**ALLEN & MAJOR
ASSOCIATES, INC.**

DRAINAGE REPORT

ADA ACCESSIBLE CURB CUT AND TRANSITION
NOT TO SCALE

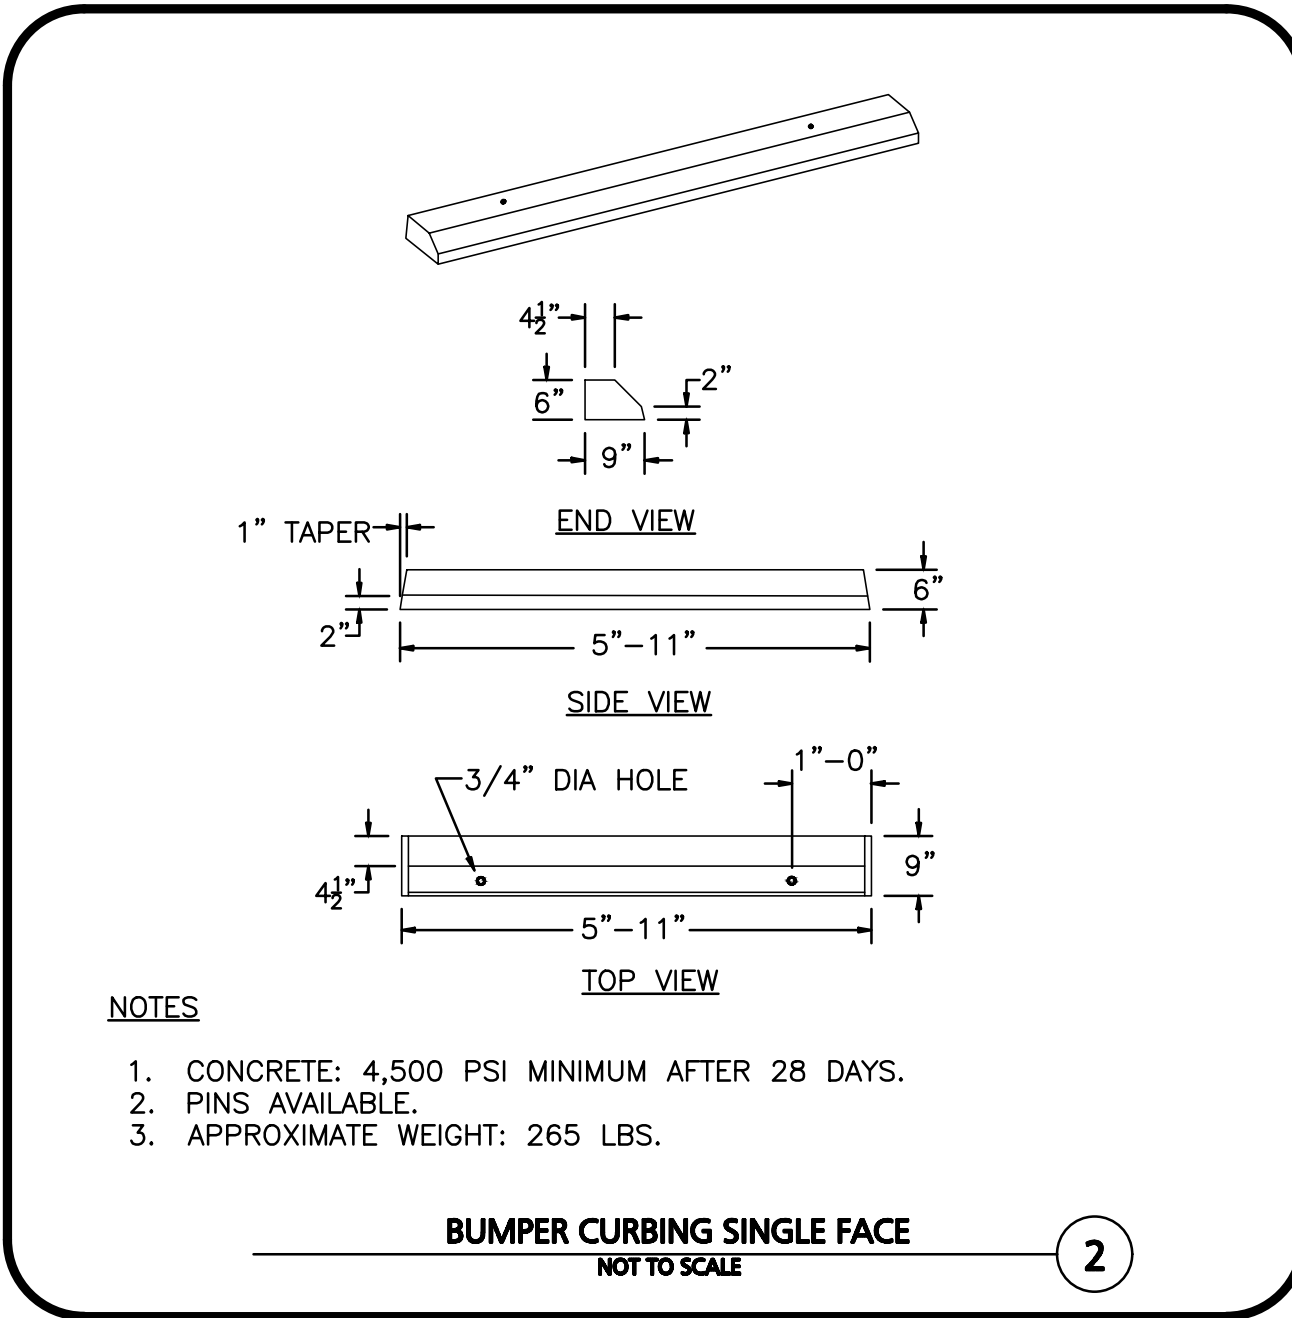
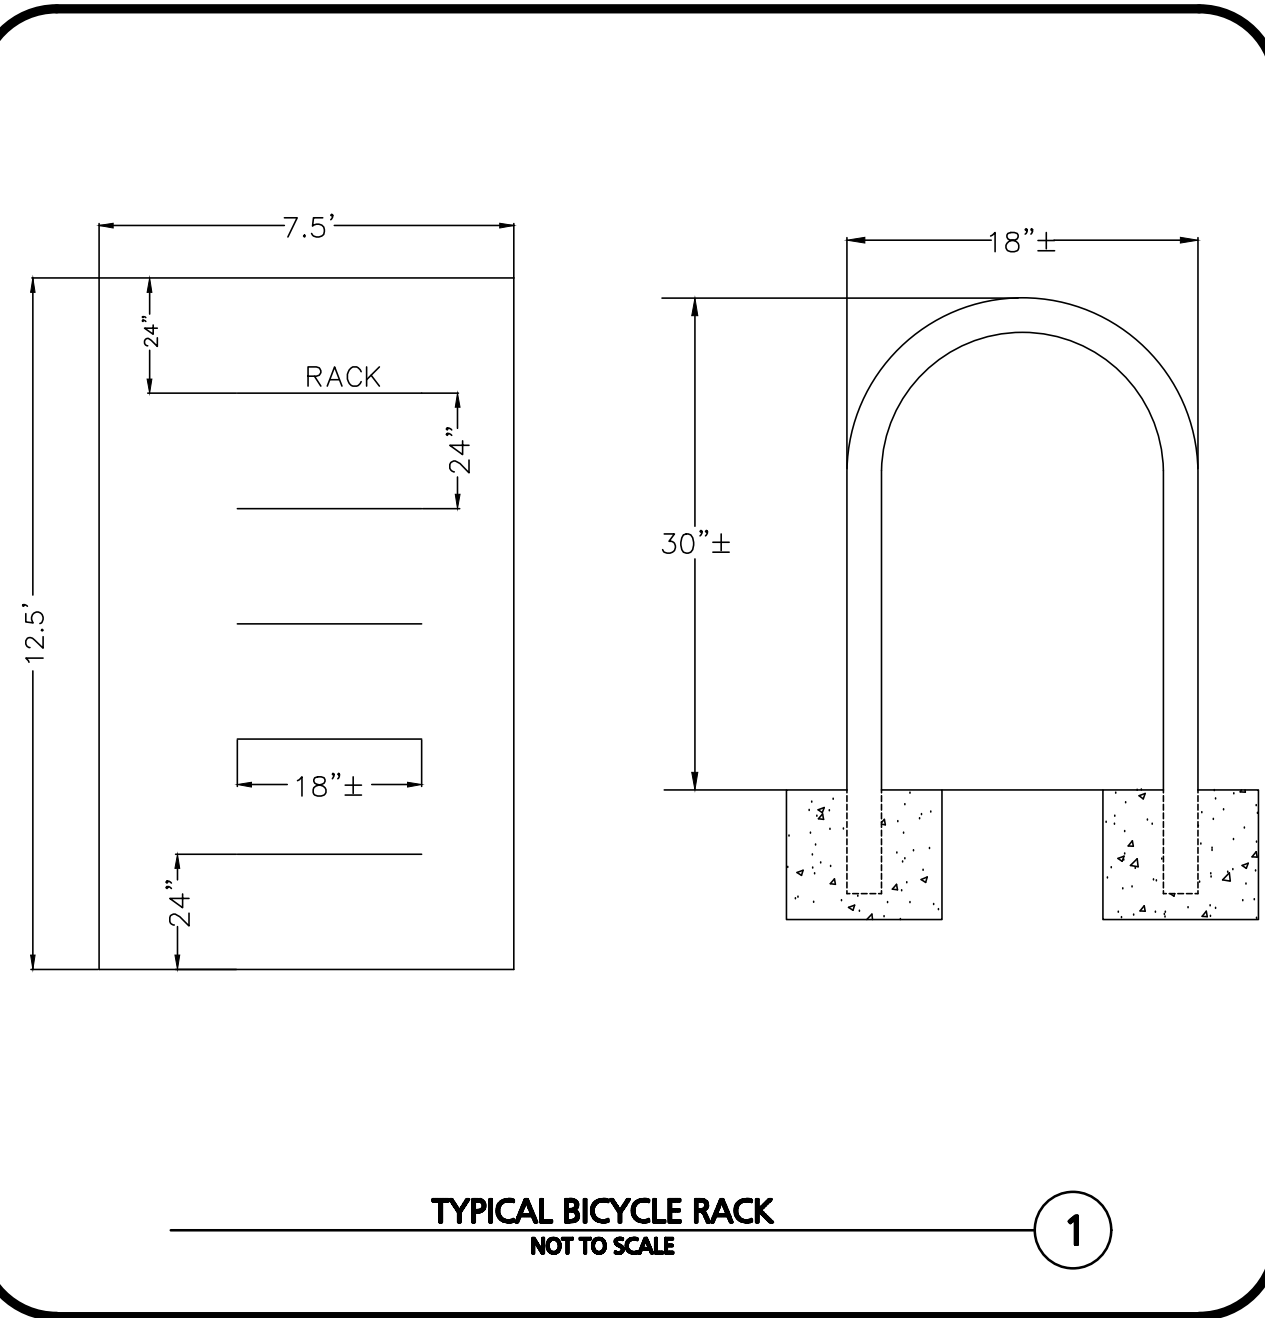
REV	DATE	DESCRIPTION
B	3/25/2024	REVISED PER TOWN COMMENTS
A	2/29/2024	REVISED PER TOWN COMMENTS
